Addendum

MPC8260AUMAD/D
Rev. 0.1, 2/2002

MPC8260 PowerQUICC II™ User's Manual: MPC8260A (HiP4) Supplement

This document describes implementation of the MPC8260A—the HiP4-process technology version of the MPC8260 PowerQUICC II microprocessor—and differences between the MPC8260A the MPC8260 (HiP3 version). All of the information in the *MPC8260 PowerQUICC II User's Manual* (which applies to the HiP3 process) also applies to the MPC8260A with the exceptions and additions noted in this document. In the event information in the two documents conflict, information presented here supersedes that in the *MPC8260 PowerQUICC II User's Manual*.

Figure 1-1 MPC826xA Block Diagram

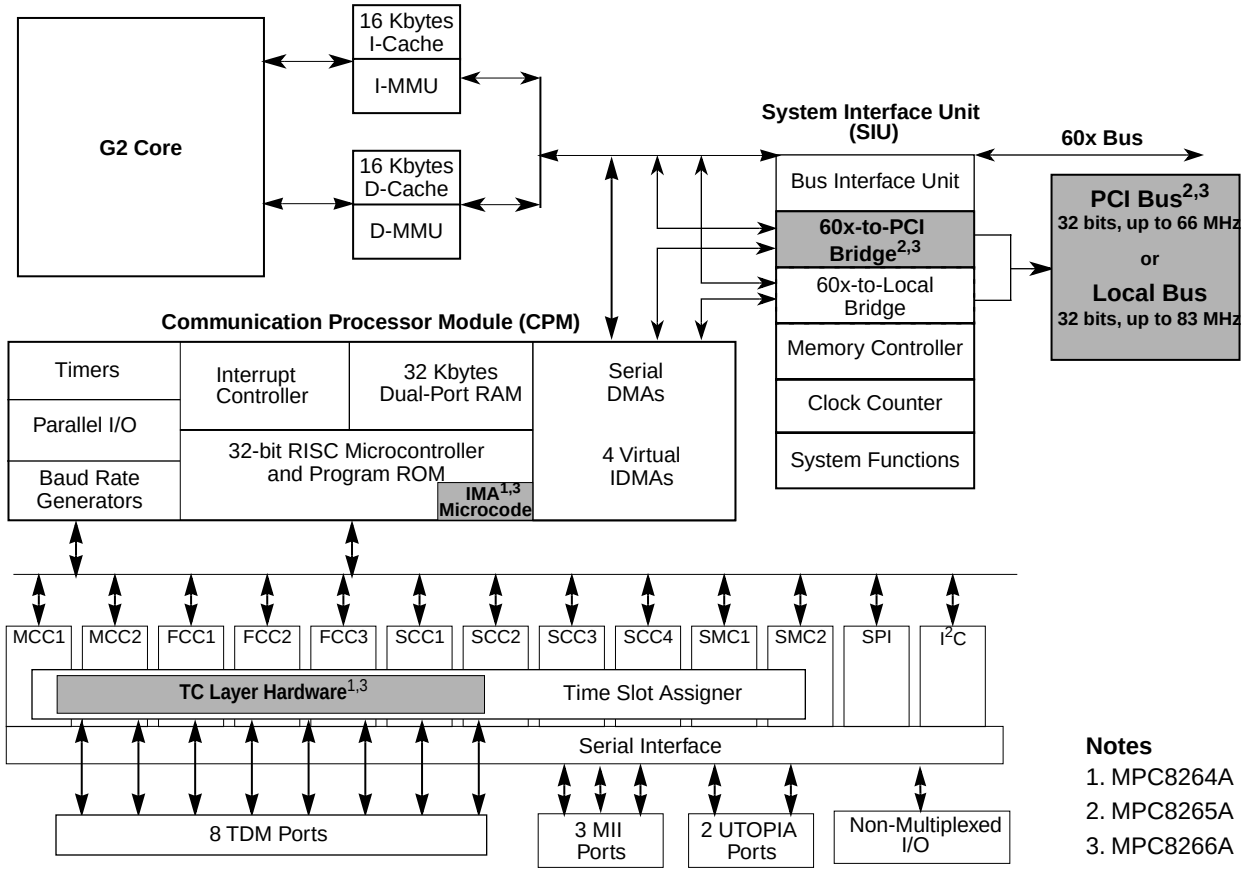
This section summarizes new features of the MPC8260A (see Figure 1-1).

Figure 1-1 shows the block diagram for the MPC8266A, the superset device.

Figure 4-8. MPC8260A Interrupt Structure

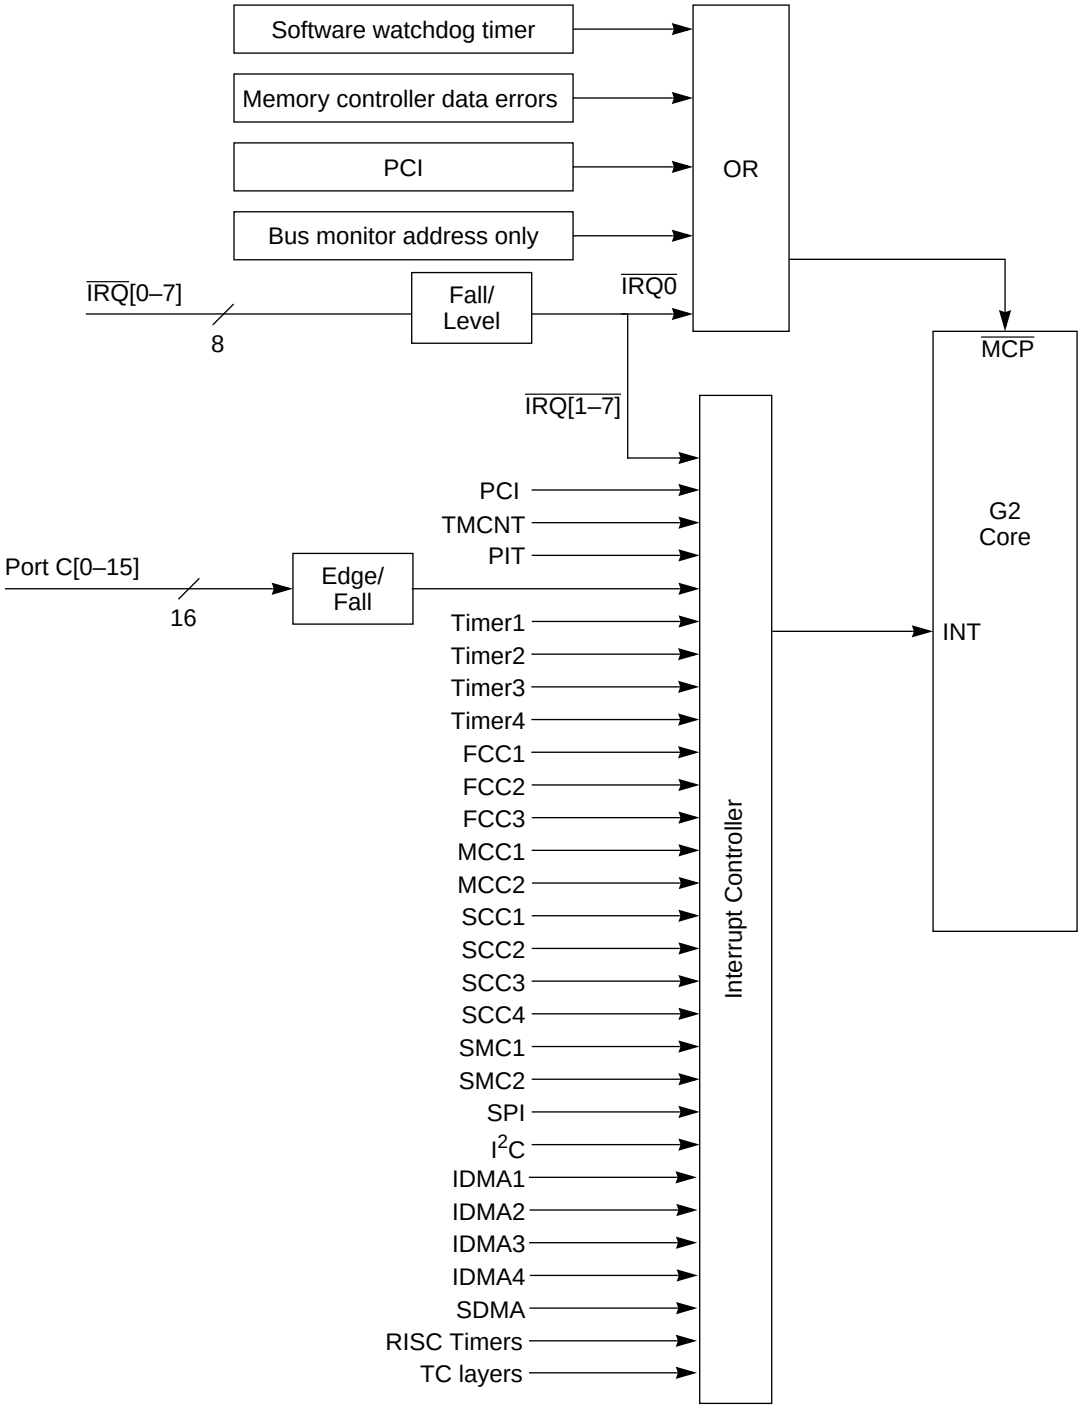
In Figure 4-8, note the MPC8260A's additional sources for machine check interrupts. Also note that in addition to the internal sources, external pins, and CPM, the interrupt controller receives interrupts from the PCI bridge (MPC8265A and MPC8266A only) and TC layer (MPC8264A and MPC8266A only).

Figure 13-8. MPC8260A Dual-Port RAM Memory Map

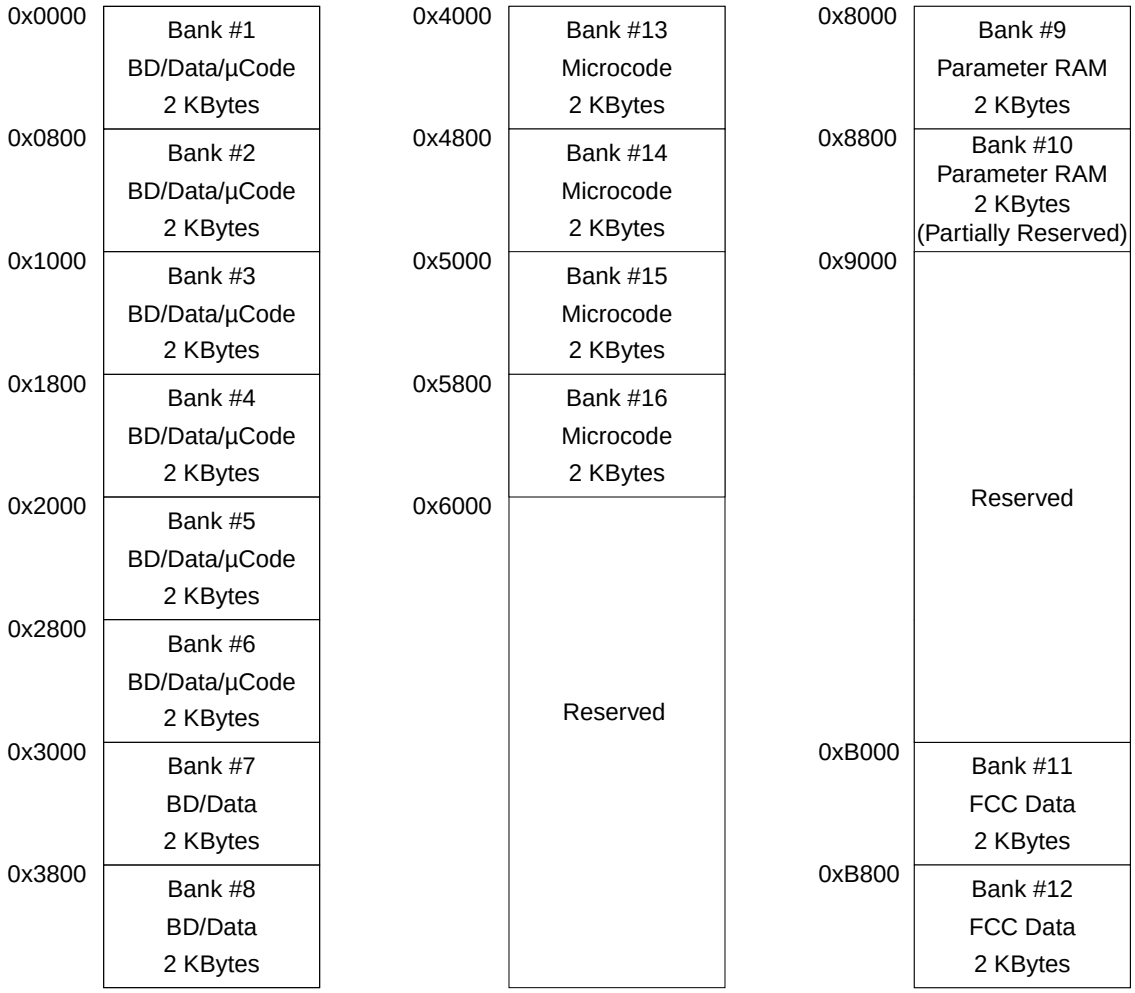
The dual-port RAM on the MPC8260A has been expanded to 32 Kbytes of static RAM. An extra 8 Kbytes starting at address 0x4000 is available for microcode execution only and cannot be used for data buffers or BDs. However, when not used for microcode, the extra 8 Kbytes can be accessed from the 60x bus for general purpose internal storage. Figure 13-8 shows the MPC8260A memory map of the dual-port RAM.
